City of Ann Arbor Design Review Board

Kerrytown Place Summary Report

February 20, 2013

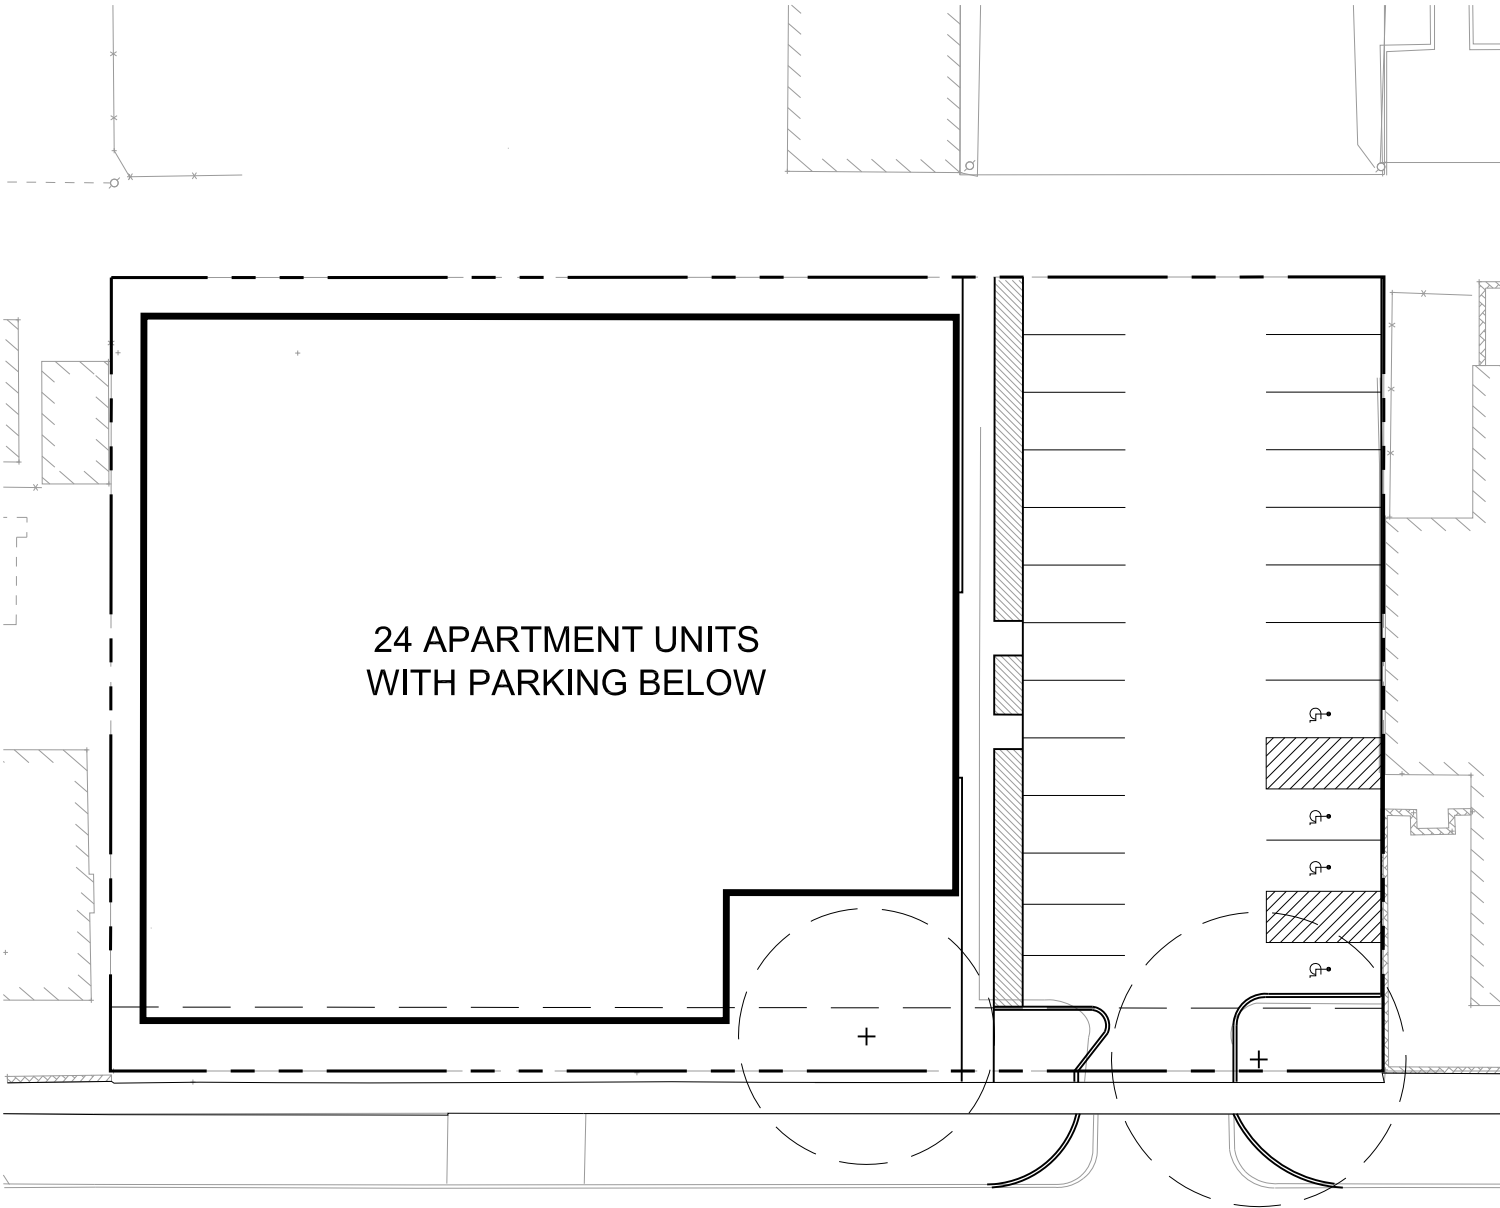
However, the Board raised three points for the design team to further consider. First, regarding the Alley building penthouses, the building is not tall enough to warrant a complete change for the top level. The change of materials to a metal screen, particularly the "putty" color, read more like mechanical unit screening than penthouses that are part of a residential unit. The Board felt that feature would not be

read correctly from the street level and suggested considering using the same materials as the lower portion of the building, changing the color of the metal material, adding more doors and windows to the penthouses, or some combination of those suggestions.
